**Notice of Intention  
To Commence Large Mining Operations**

**US Oil Sands (Utah) Inc.  
PR Spring Mine  
M0470090**

May 2009

**Earth Energy Resources**  
**Figure 3**  
**PR Spring Plant Site - Plot Plan**  
**Preliminary Equipment Layout - Rev.4**

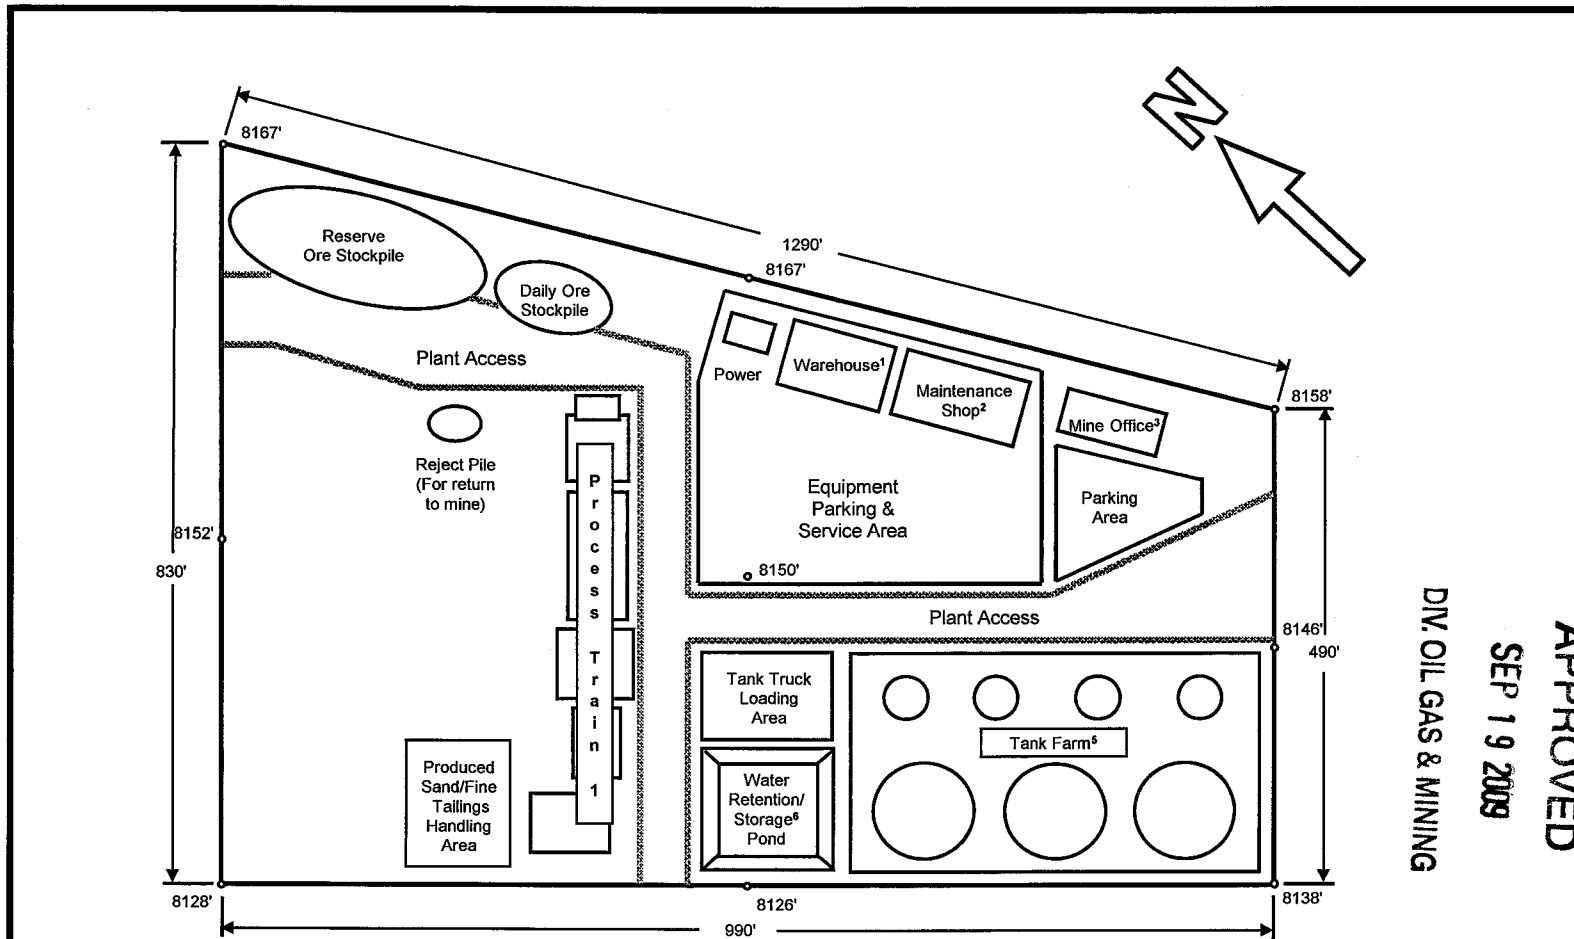
Figure 3	Define 203 acres listed in text and in bonded area. (lah)	B	Please see the response to Comment #6. Also note that acreage values have been refined throughout the current version of the NOI.

Comment #	Sheet/Page #	Comments	Review Action	Earth Energy Responses
12	Figure 3	Label figure 3 - features to be tied to surety bond (lah)	A	There is no good way to add all of the surety information onto this figure. The surety table includes references to these features and the assumptions used therein and does not need to be duplicated on this figure.
13	Figure 3	The facilities map should include the dimensions of the buildings, ponds, piles etc. These dimensions can be part of the legend and referenced appropriately. The map should show roads, including access and haul roads; utilities and power lines (water, gas, power, telecommunications etc); and drainage control devices. (BE) Maximum size of the facilities are needed for bonding calculation purposes. (lah)	A	Earth Energy respectfully disagrees that dimensions should be placed on Figure 3 for every specific structure, for the following reasons. First, with the additional labeling already added to this figure in response to Comment 12, the figure is simply too cluttered to contain the additional information. Second, the figure is meant to represent the conceptual plans for the surface facility, as they are currently known; detailed engineering designs have not yet been prepared and Earth Energy has committed to submit those detailed designs, which will include dimensions, once they are available. Third, the figure as is contains overall site dimensions, from which the relative and general sizes of the specific features within the site can be generally and easily inferred. Last, Earth Energy recognizes that dimensions are important for surety purposes; to that end, the bond calculation worksheets spell out the presumed maximum sizes for specific structures.

This is now Figure 3. Where known, dimensions have been added; however it is key to note that the plant site and mine plan designs are still in the engineering phase and are somewhat conceptual. When engineering is complete, Earth Energy will provide additional detailed drawings; at this time, all disturbances will be confined within the areas stipulated, will be laid out generally as shown, and will not result in disturbances greater than or significantly different than indicated. The well site and water line/power cable corridor has been added to various figures, sediment and drainage control features have been added to Figures 2 and 3. Utility lines are not present, other than the already noted pipeline corridor that appears on Figure 2.

**Figure 4a**  
**Earth Energy Resources Inc. - PR Spring Oil Sand Mine**  
**Transverse Mine Section W1-E1 Rev.3**

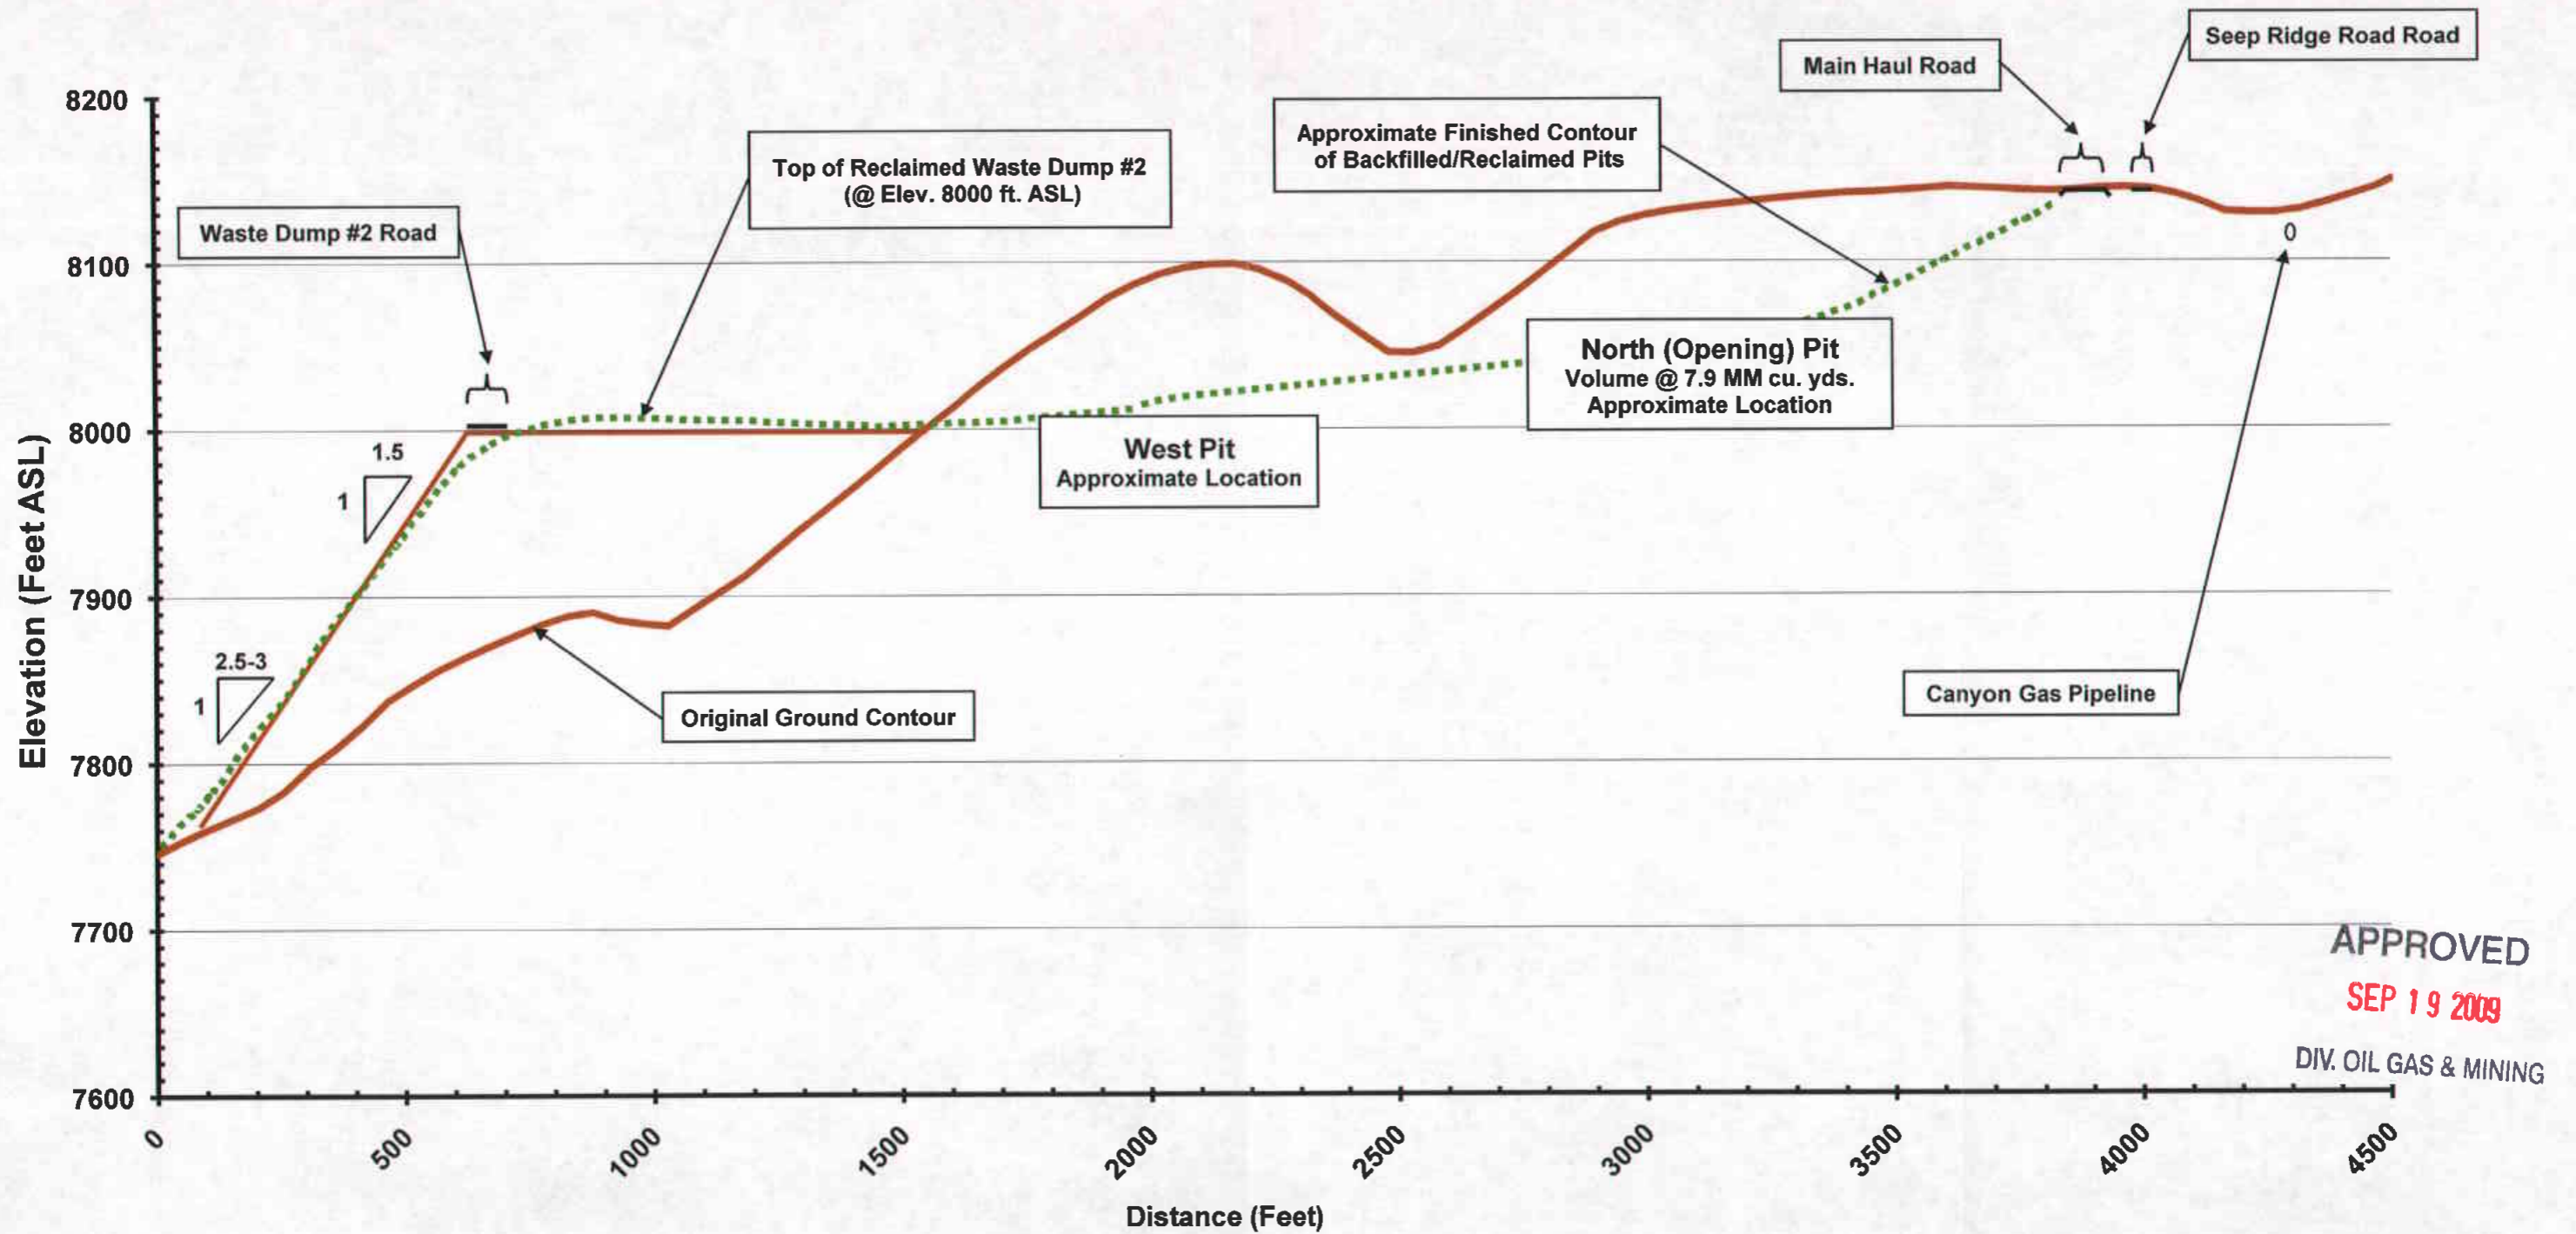
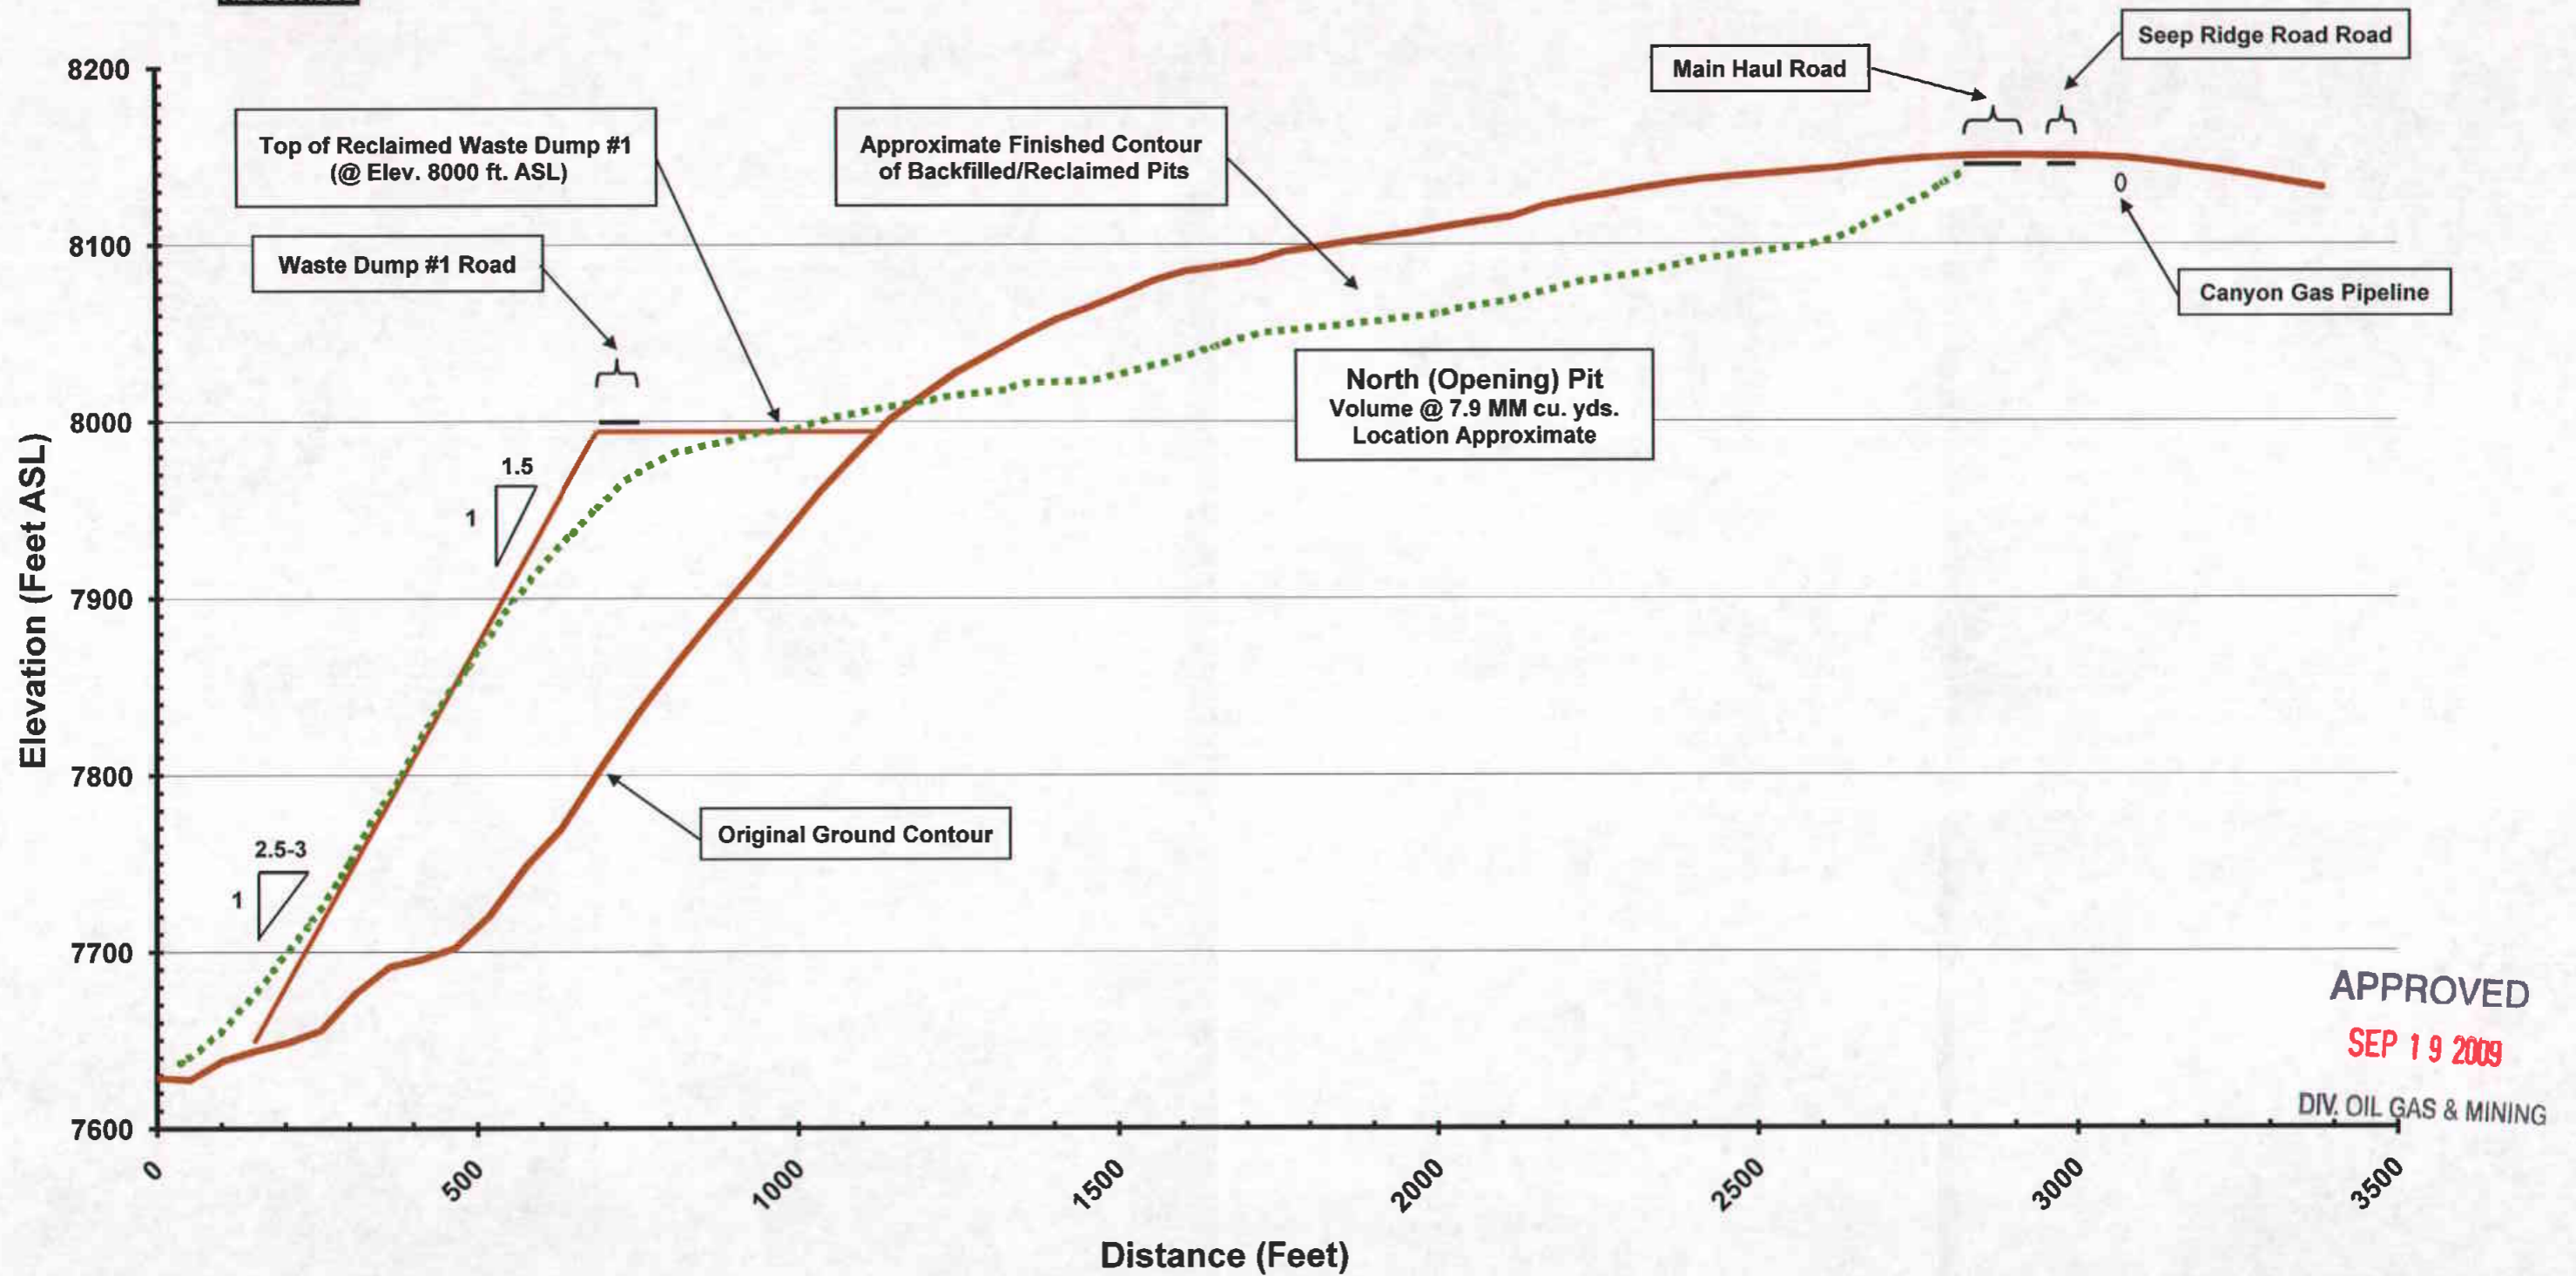
14	Figure 4a,4b,4c,6	FYI only, best if drawn with no vertical exaggeration, best if all x-sections are the same scale, engineering standards for drawing are lacking (lah)	A	Earth Energy respectfully disagrees that these cross sections are best shown without vertical exaggeration. Necessary detail would be lost if scales were equivalent, and vertical exaggeration is a standard practice to solve this problem. No changes to the scale of these drawings have been made.
15	Figure 4a,4b,4c	Slope angles shown on x-section are incorrect. (lah)	A	Earth Energy believes that the shown slope angles on all three of these figures are correct. Please note that a replacement for Figure 4b was submitted to the Division on May 15, 2008 to correct an error in the May 2008 2 <sup>nd</sup> draft NOI submittal.
16	Figure 5	As per 105.3.16 A geology map is required, include Geomechanical data; include orientation of bedding and structural features include faults, and joint sets orientations to demonstrate pit wall stability . (lah)	B	In response to a comment in the Division's Initial Review, the best available geologic map was provided as Figure 5 in the May 9, 2008 2 <sup>nd</sup> draft NOI. The response letter accompanying that 2 <sup>nd</sup> draft stated that it was the best available map. As requested by Comment # 40, generalized strike/dip information for bedding has been added to Figure 5. The other more detailed geologic information that the Division is requesting is simply not available, to Earth Energy's best knowledge, so it cannot be added to the map.

15	Figure 4a,4b,4c	Slope angles shown on xsection are incorrect. (lah)	
16	Figure 5	As per 105.3.16 A geology map is required, include Geomechanical data; include orientation of bedding and structural features include faults, and joint sets orientations to demonstrate pit wall stability . (lah)	
17	Figure 5-d	There may be related issues within the other figures and more information may be required. (BE)	
18	Figure 5-d	Is this figure to remain in the plan? Why is it labeled proprietary & confidential? (lah)	
19	Figure 9	Good regrading plan. Better scale and more detail needed (match to surety bond) needed (lah)	
20	General	As per 105.3.16 A geology map is required, include Geomechanical data; include orientation of bedding and structural features include faults, and joint sets orientations to demonstrate pit wall stability. (lah)	
21	General	A map should be submitted that shows adjacent land owners, including access road from the nearest public state road. (BE) As per 105.3.18 County road is not labeled on Figure 1 as written in text page 10 para 5 (lah)
